Development Assessment Panel Minutes

17 August 2015

2.1 DEVELOPMENT APPLICATION 155/C050/2014 – MR M MILICEVIC – 20 RIVER STREET, ST PETERS & PORTION OF 10 PLAYER AVENUE, ST PETERS

DESCRIPTION OF DEVELOPMENT: Community Title Land Division (creating three (3) individual allotments and a common driveway area)

Figure 4

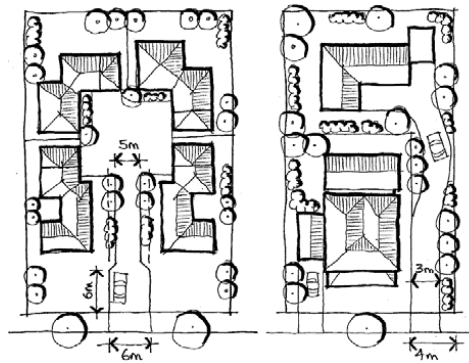
- (ii) not less than 6 metres in width for at least the first 6 metres and 5 metres in width thereafter, for a site that accommodates three or more dwellings (Refer to Figure 4).

The proposed driveway access/egress point adjacent River Street is only 3.76m wide, which gave rise to initial concerns regarding the ability for future occupiers and/or visitors to safely and conveniently access and egress the proposed common driveway. The Applicant approached the owner of 18 River Street in order to determine if an agreement could be reached whereby either:

- a right of way could be obtained over a portion of their land to provide a 6m x 6m access point to the subject land, or
- the existing fence dividing 18 and 20 River Street could be lowered for a portion of length in order to enable improved driver sightlines to be achieved.

Subsequently, the Applicant engaged the services of a traffic engineer, Mr Paul Morris from GTA Consultants, to review and provide a report with respect to how safe and convenient, from a traffic engineering perspective, the access/egress point to River Street is. Mr Morris has advised that a 3.3 metre wide driveway can be accommodated at the River Street frontage which satisfies the requirements of *Australian Standard 2890.1:2004* insofar that the anticipated number of predicted traffic volumes to the three (3) proposed allotments is relatively low (ie. 27 trips per day). In terms of providing adequate driver sightlines (given that the 1.8 metre high fencing between 18 and 20 River Street is to remain unchanged), Mr Morris has suggested that a driver assisted vision mirror can be installed on the land that would enable motorist(s) sightline vision to and from the proposed driveway entrance to be improved.
